In response to Manti-Lasal National Forest's letter dated January 13, 1982 we have revised the appropriate drawings to comply with the summary of comments offered in the letter. A summary of what has been done follows:

Crandall Canyon Mine Site Plan Design Narrative

SUBJECT: Supplemental Study for Sedimentation Pond Stability at Crandall Canyon Mine

EMBANKMENT SLOPE STABILITY STUDY
SEDIMENTATION POND
CRANDALL CANYON MINE
HUNTINGTON, UTAH

FB
GRID
PROJ. NO. 161031
DWG. NO. Fig. 6

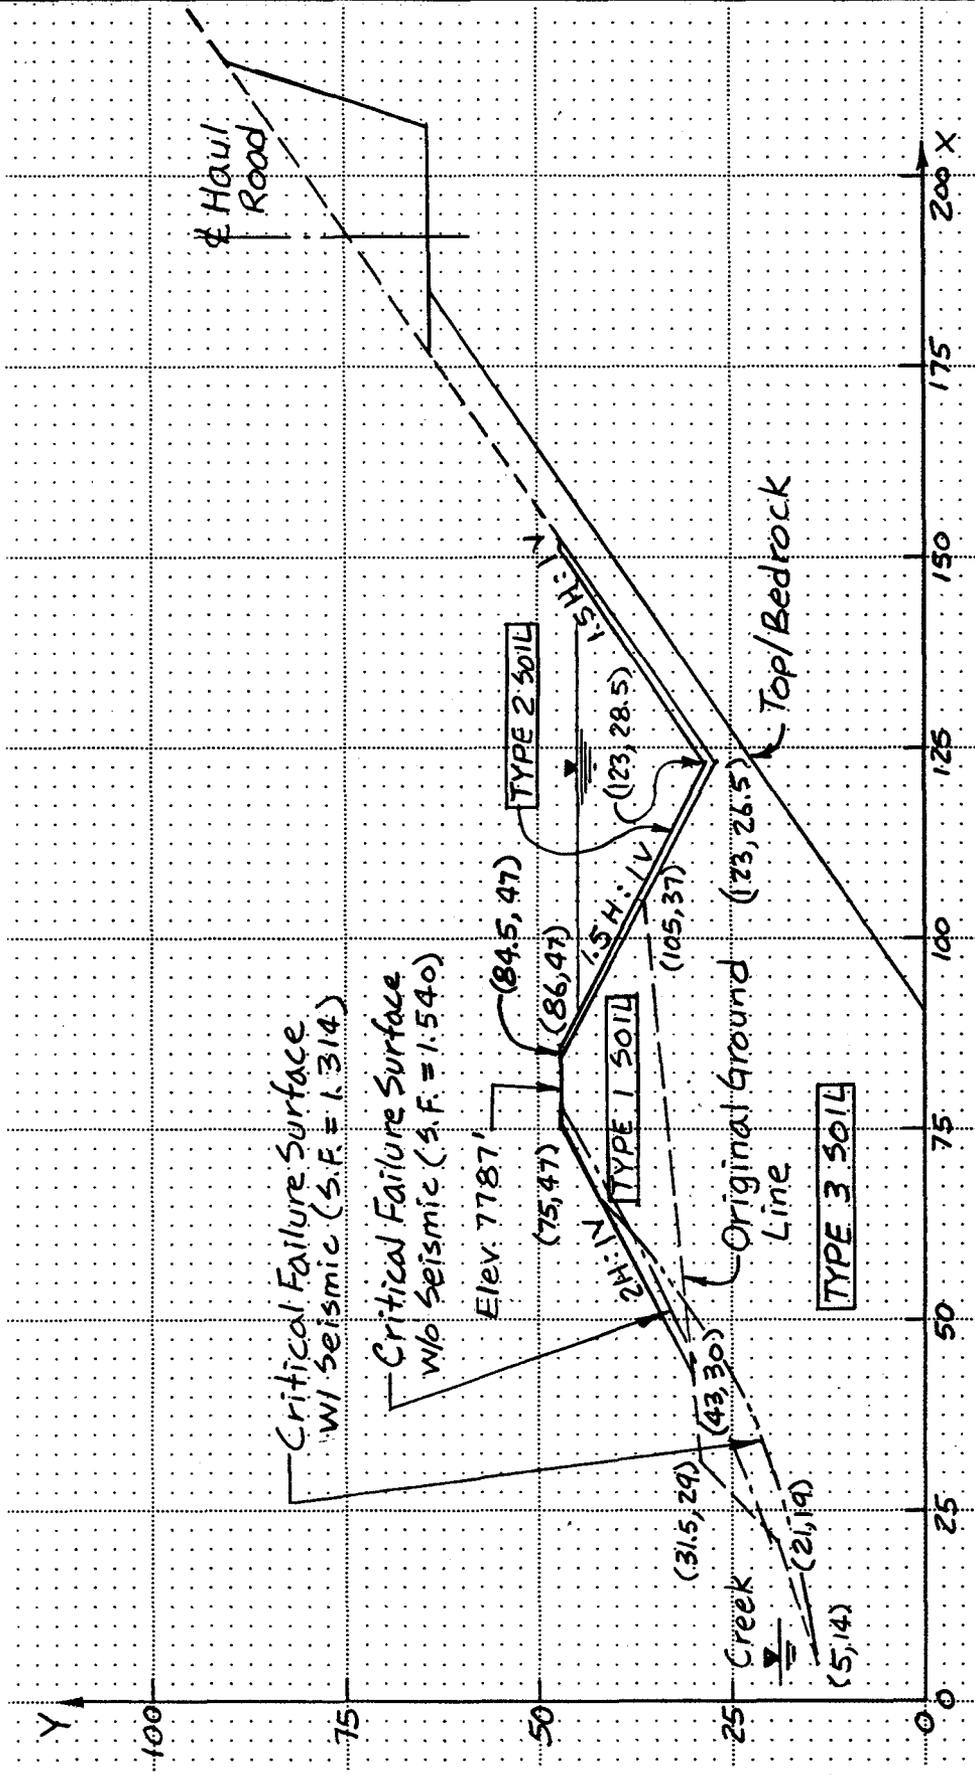
In order to improve the factors of safety of the downstream slope of the pond embankment, the typical cross-section of the pond was revised by Boyle Engineering Corp. of Price, Utah as shown in Fig. 6 attached herewith. The crest of the pond was lowered to Elev. 7787 ft, the upstream slope of the pond embankment was steepened to 1.5H:1V, and the pond floor was lowered to Elev. 7769 ft to form a V-shape. Due to those changes, the pond embankment was shifted slightly toward the hillside.

The same soil parameters as in the original study was used in the STABL2 computer program for the analysis of the slope stability of the downstream slope. For a 2H:1V slope, the factor of safety is 1.540 under static conditions and 1.314 under seismic conditions (with unassumed horizontal acceleration equal to 8% of gravity). A set of copies of the computer output is attached.

The factors of safety of the revised cross-section of the sedimentation pond, as shown in Fig. 6, provide an adequate margin against slope failure. We will be glad to answer any questions you may have regarding this supplemental study.

FB.
 GRID.
 PROJ. NO. 161031
 DWG. NO. Fig. 3

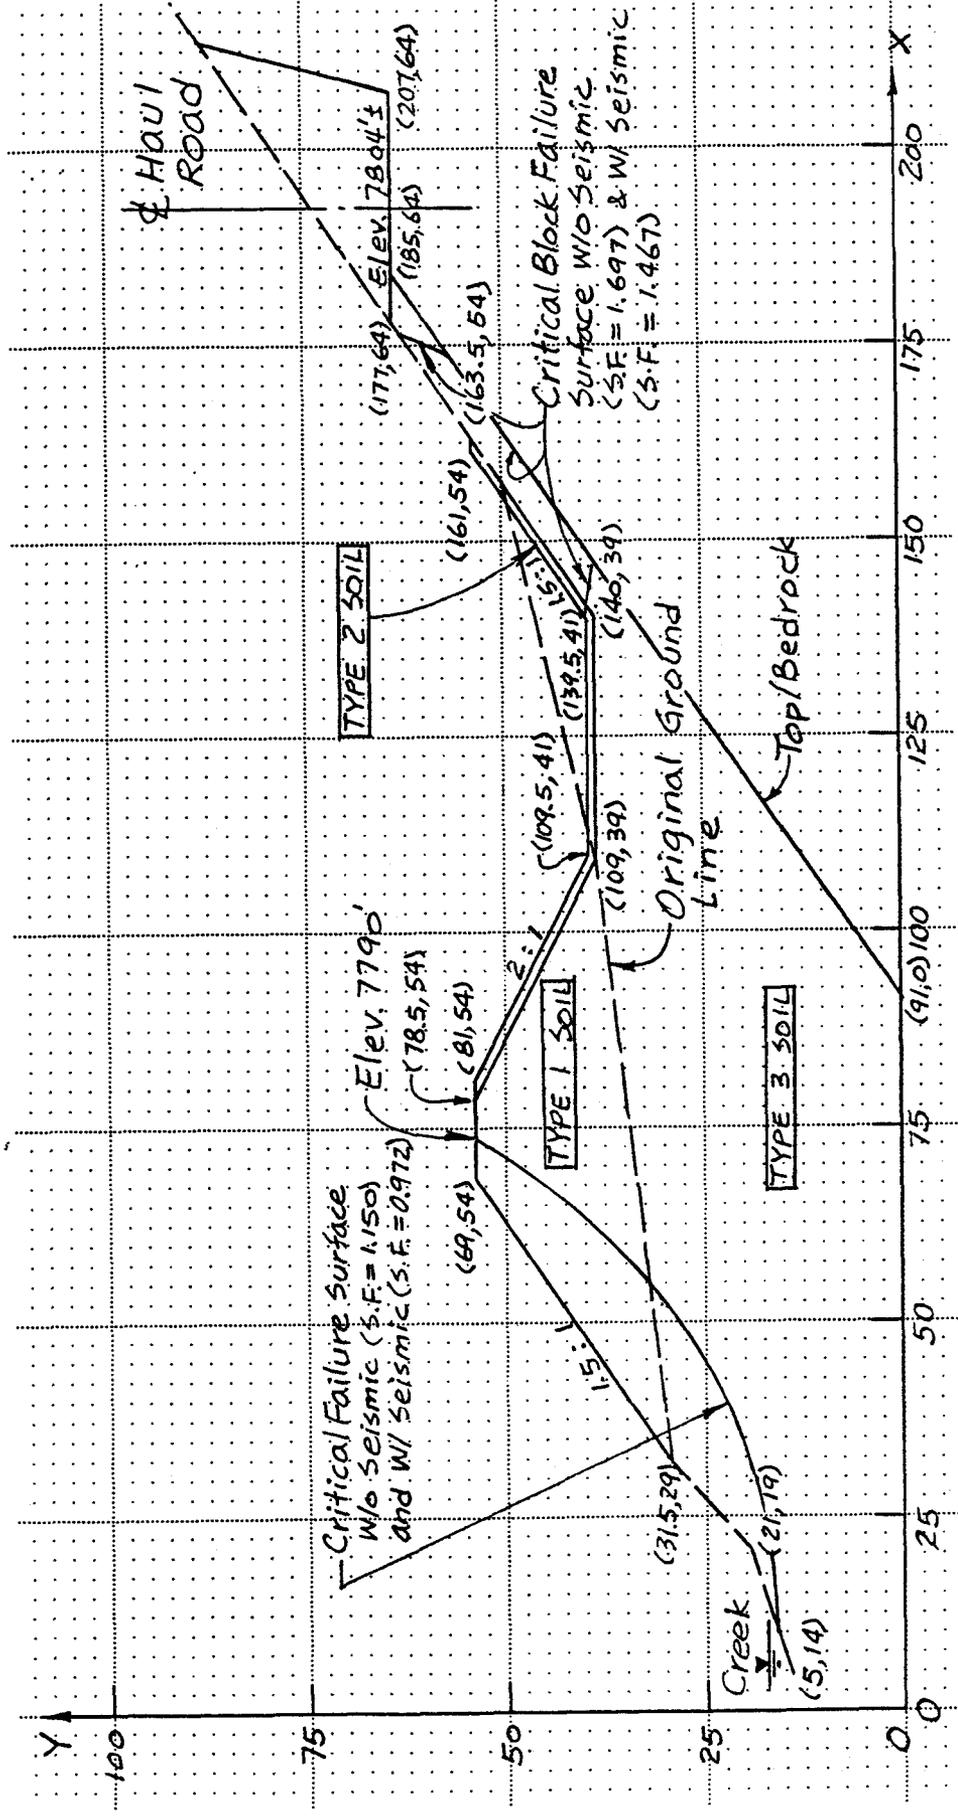
According to the results of the STABL2 computer program, the design slopes of the haul road embankment ($1\frac{1}{2}H:1V$) and the upstream slope ($2H:1V$) of the pond embankment have more than adequate factors of safety against slope failure (see Table 1). The factors of safety, for the design slope ($1\frac{1}{2}H:1V$) of the downstream slope of the pond embankment is 1.15 without seismic load and 0.972 with seismic load, regardless of the level of water inside the pond. These are considered as inadequate.

To increase the stability of the downstream slope of the pond embankment, the slope was flattened to $1\text{-}3/4H:1V$ and subsequently to $2H:1V$, and the stability was re-analyzed. The factors of safety are 1.198 without seismic load and 1.059 with seismic load for the $1\text{-}3/4H:1V$ slope; and are 1.357 without seismic load and 1.081 with seismic load for the $2H:1V$ slope. The $2H:1V$ slope is considered adequate against slope failure for the downstream slope of the pond embankment.

Based on the results of the slope stability analyses, utilizing the STABL2 computer program, two of the three design slopes of the sedimentation pond are considered stable. The design slope (2H:1V) of the upstream slope of the pond embankment and the design slope (1½H:1V) which forms the upstream embankment, are both determined to be more than adequate against slope failure for all cases analyzed. The design slope (1½H:1V) of the downstream slope of the pond embankment does not have adequate factors of safety and should be flattened to at least 2H:1V.
